Response to

Request for Additional Information No. 378(4409, 4513, 4490), Revision 2, Supplement 7

U. S. EPR Standard Design Certification
AREVA NP Inc.
Docket No. 52-020
SRP Section: 06.02.01 - Containment Functional Design
SRP Section: 06.02.02 - Containment Heat Removal Systems
SRP Section: 06.02.03 - Secondary Containment Functional Design

Figure 06.02.01-87-01 — Temperature in L1 and L2 Upper Equipment Room

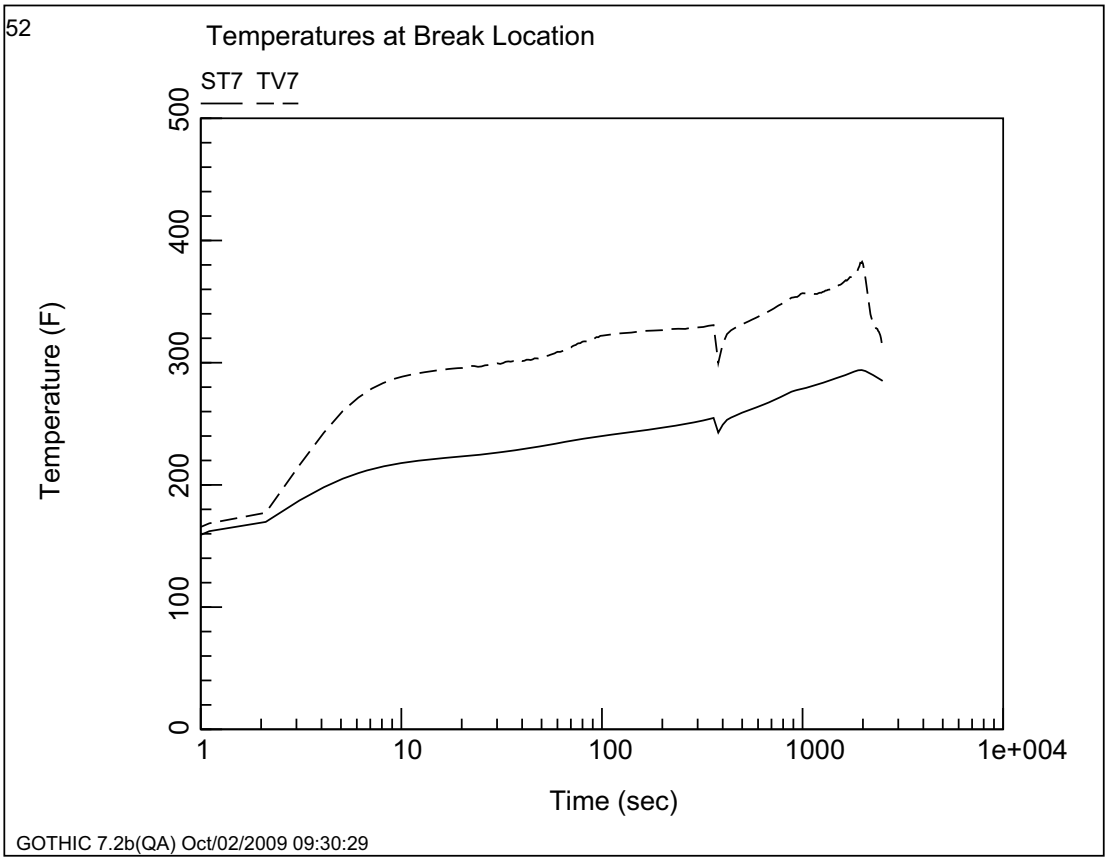
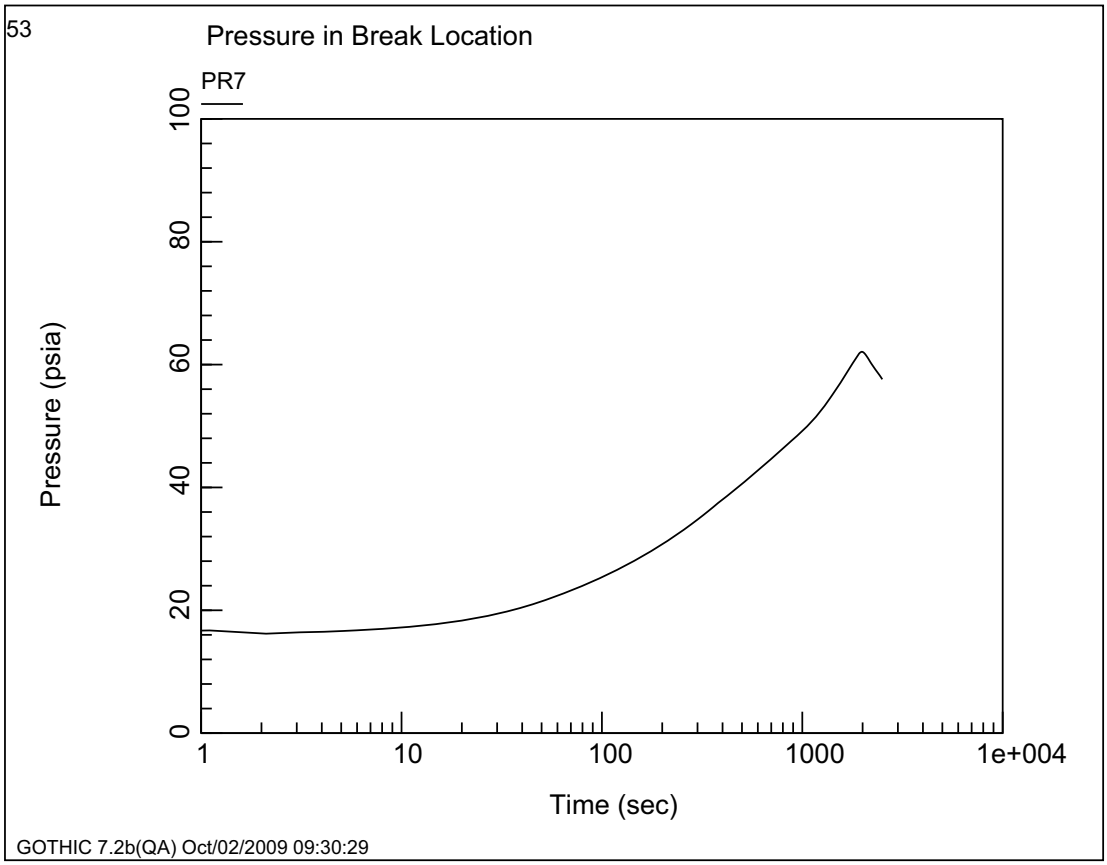
c) The location of the maximum atmospheric temperature (elevation, and local subdivided cell number or lumped parameter node number)
   d) Time history plots for maximum atmospheric temperature location and pressure. The atmospheric temperature plot should include both gas (vapor) and saturation temperatures.

d) Figure 06.02.01-87-01 and Figure 06.02.01-87-02 show the time history atmospheric temperature and pressure plots for the location where maximum temperature occurs, Node 7.

Figure 06.02.01-87-03 — Temperatures of Nodes 1 and 2

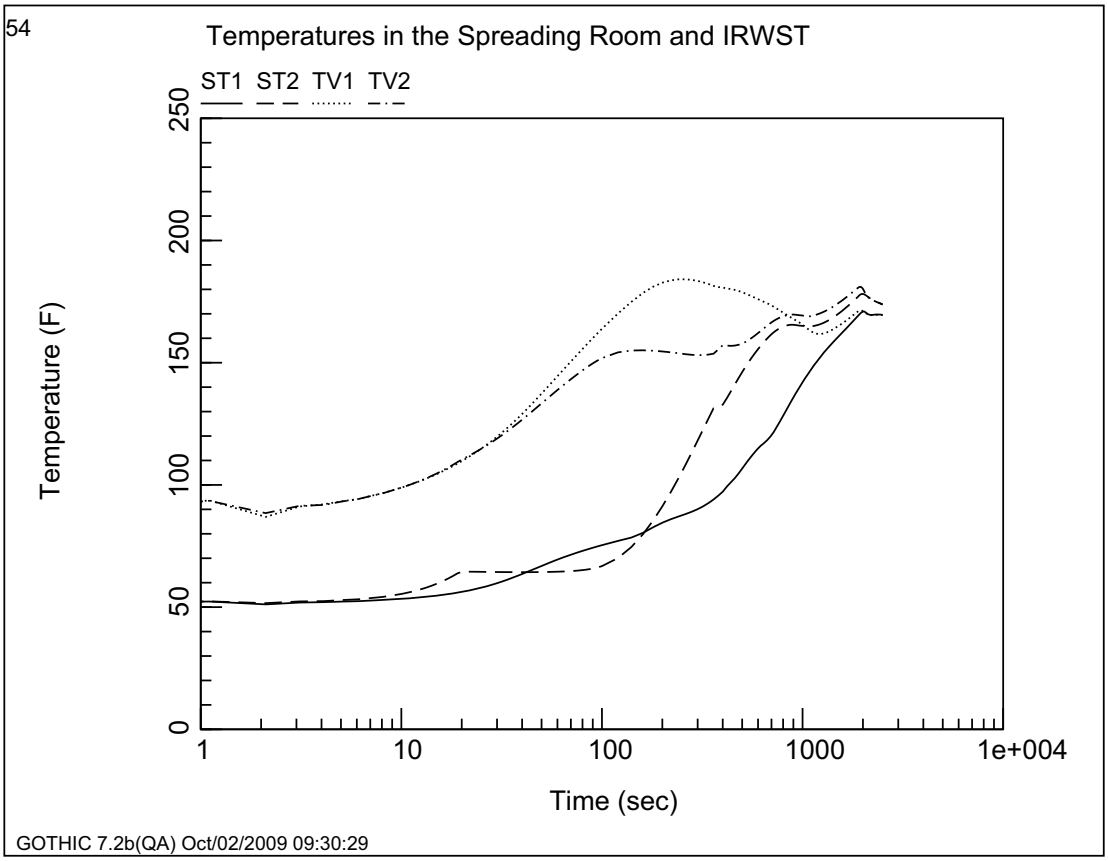
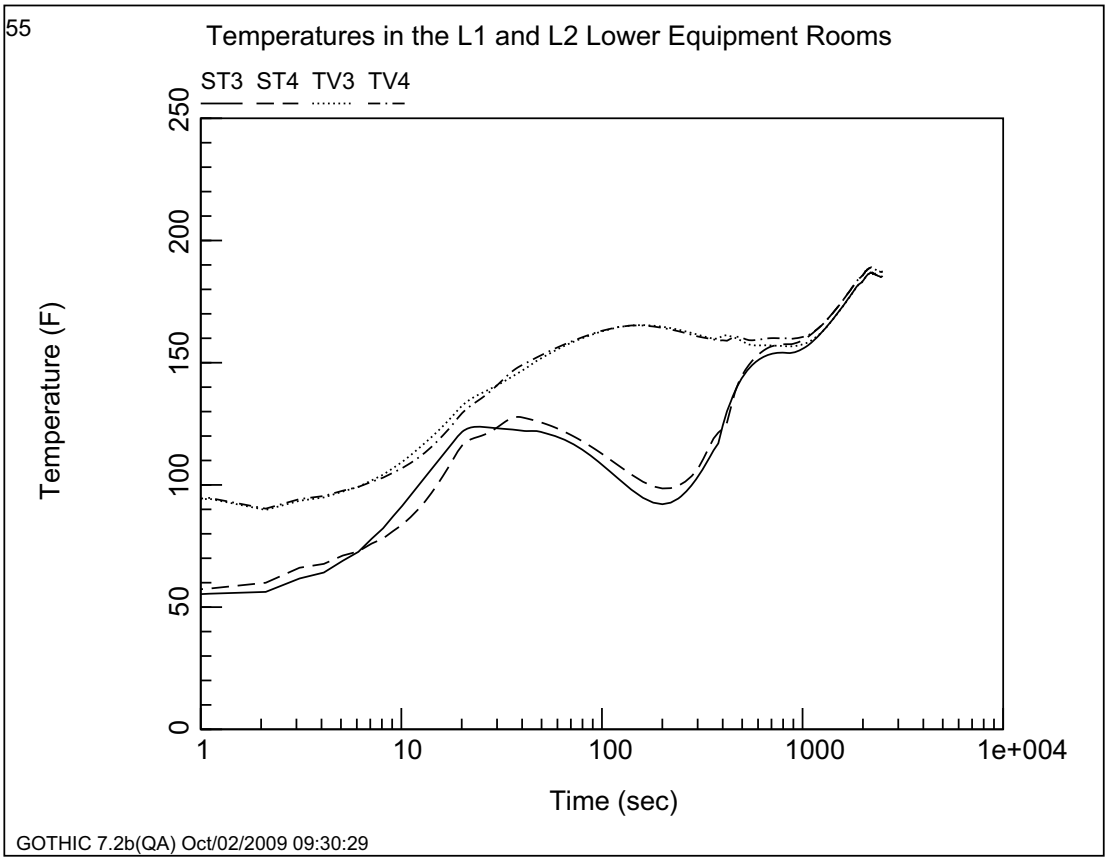
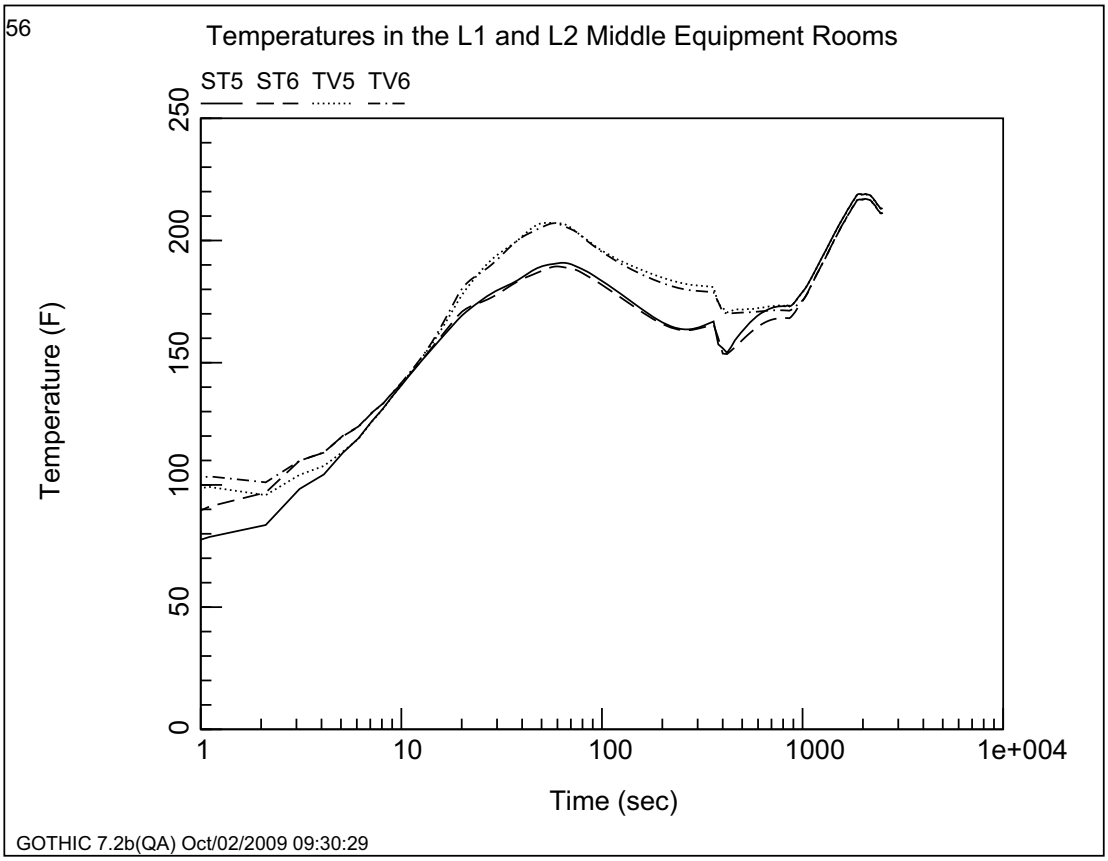
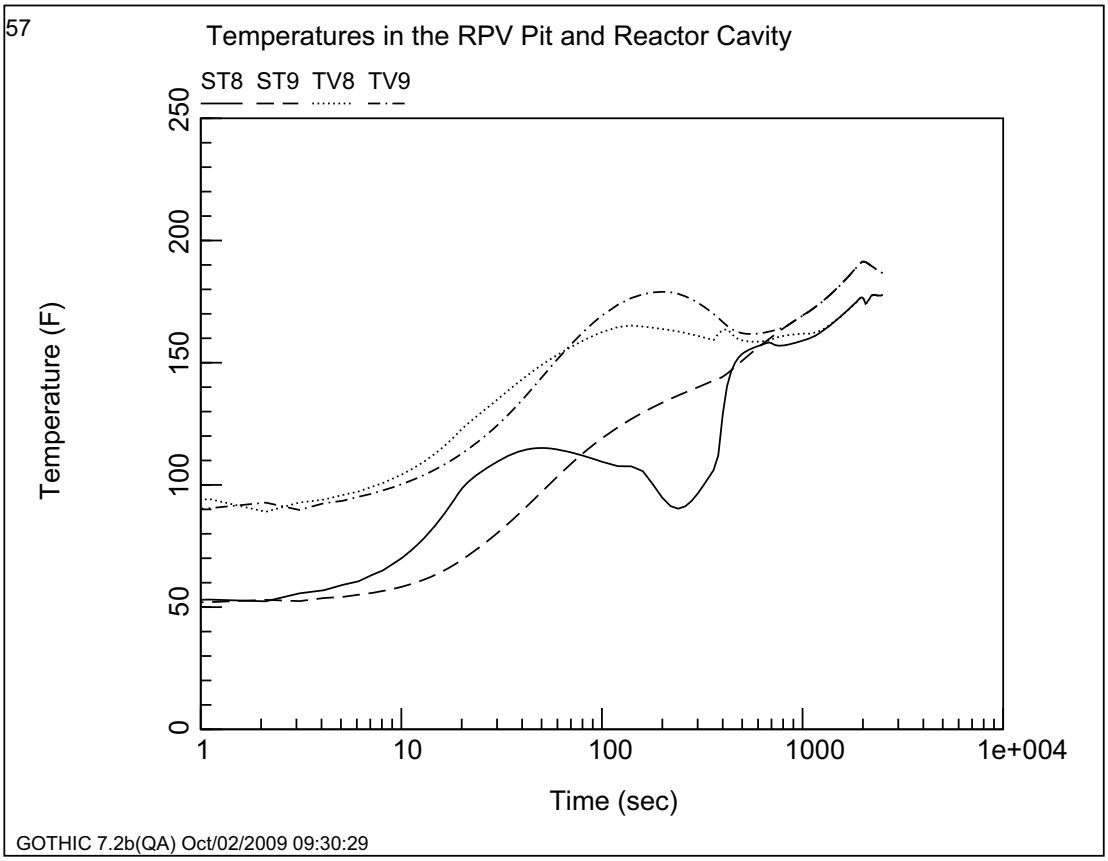
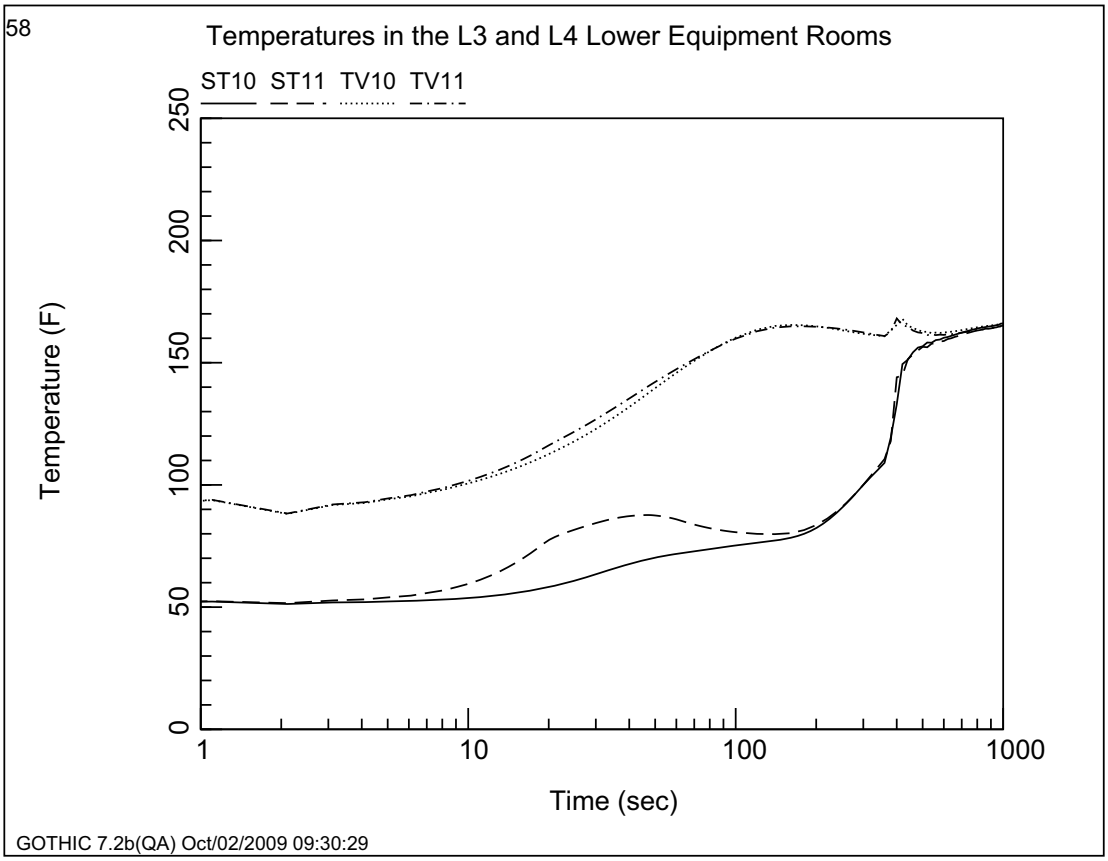
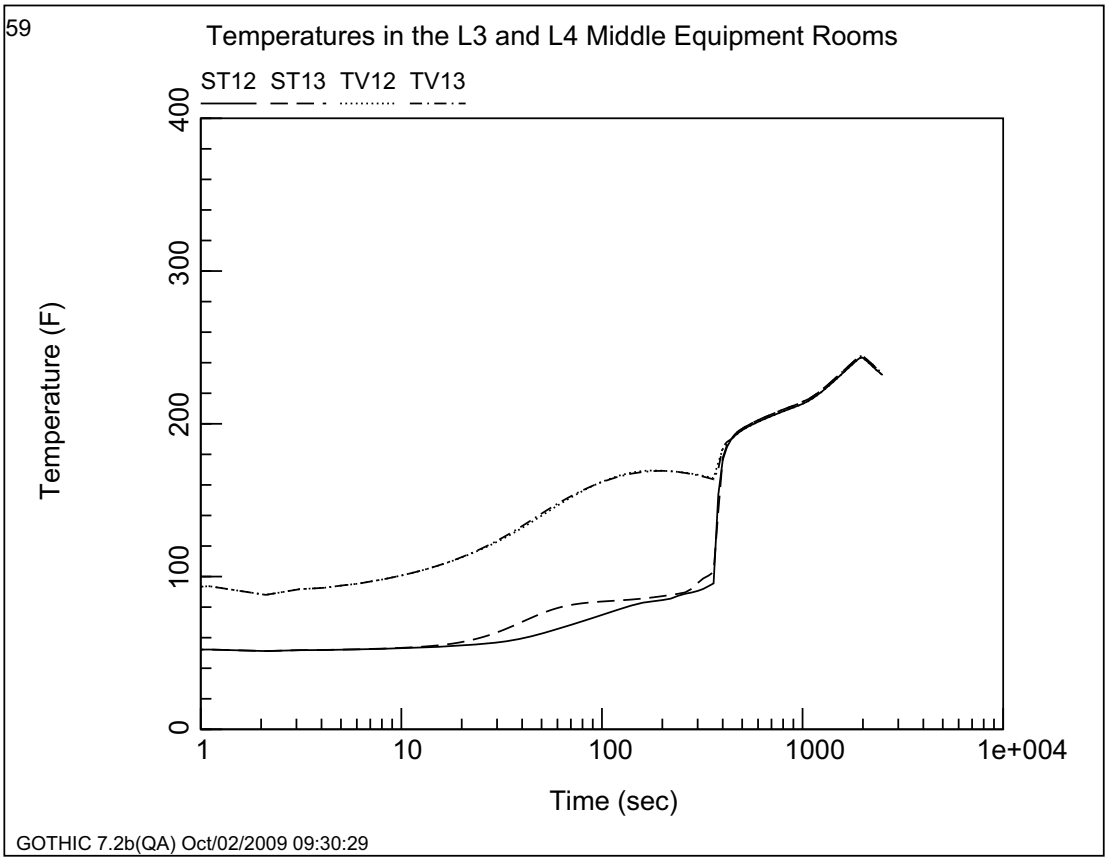
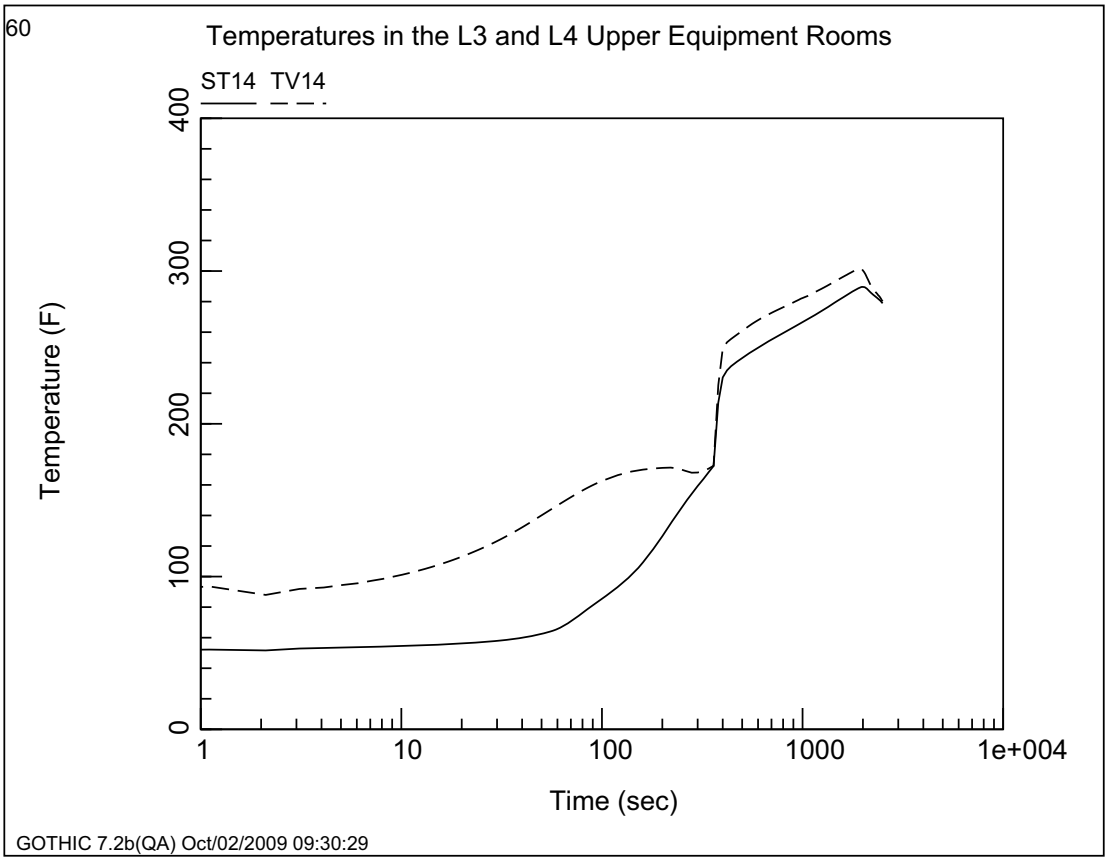
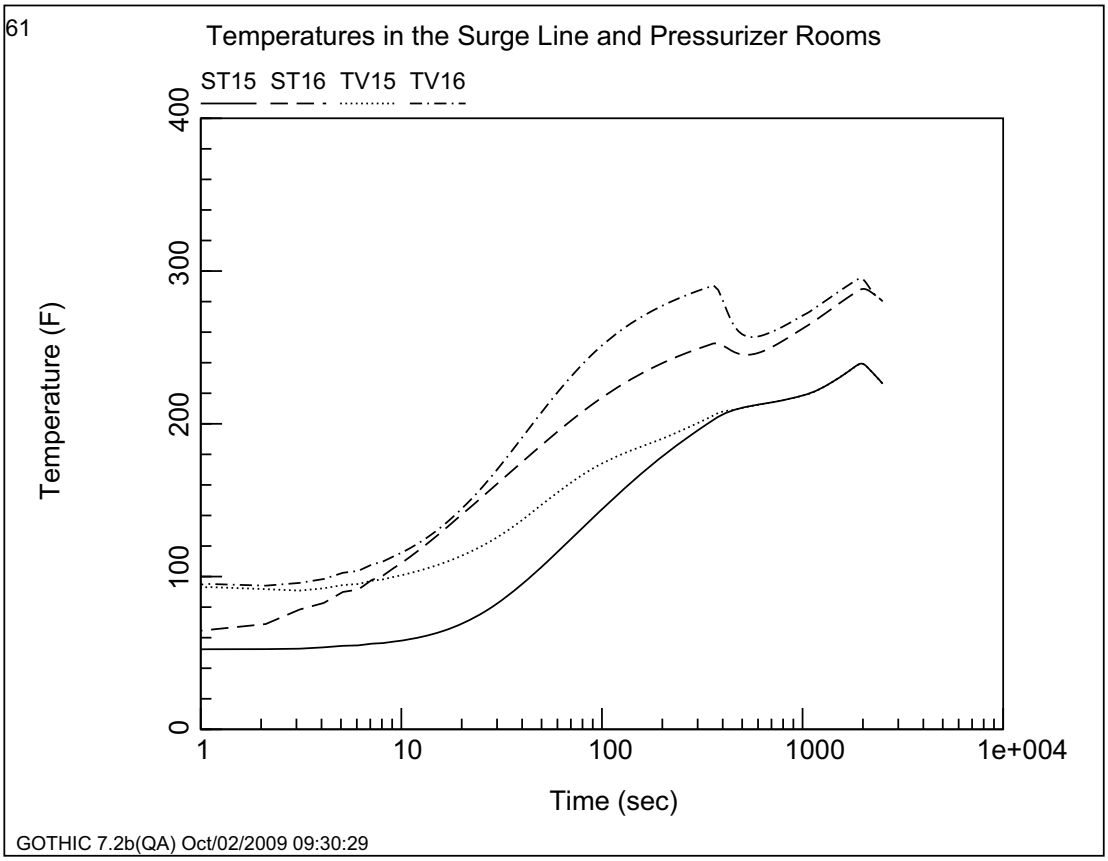
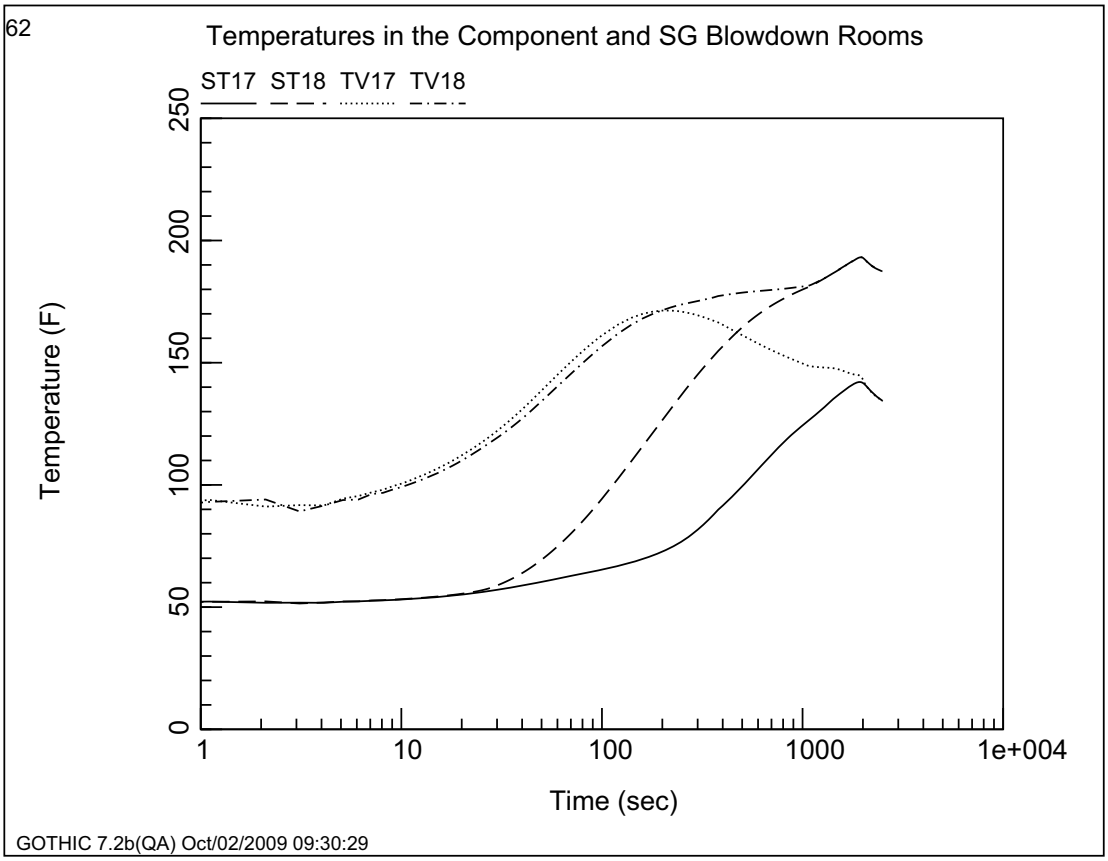
e) Time history atmospheric temperature plots for lumped parameter nodes below the dome (nodes 1-30, excluding node 25). The atmospheric temperature plots should include both gas (vapor) and saturation temperatures.

e) Figures 06.02.01-87-03 through 06.02.01-87-17 and Figure 06.02.01-87-01 show the time history atmospheric temperature plots for nodes 1 through 30, excluding Node 25.
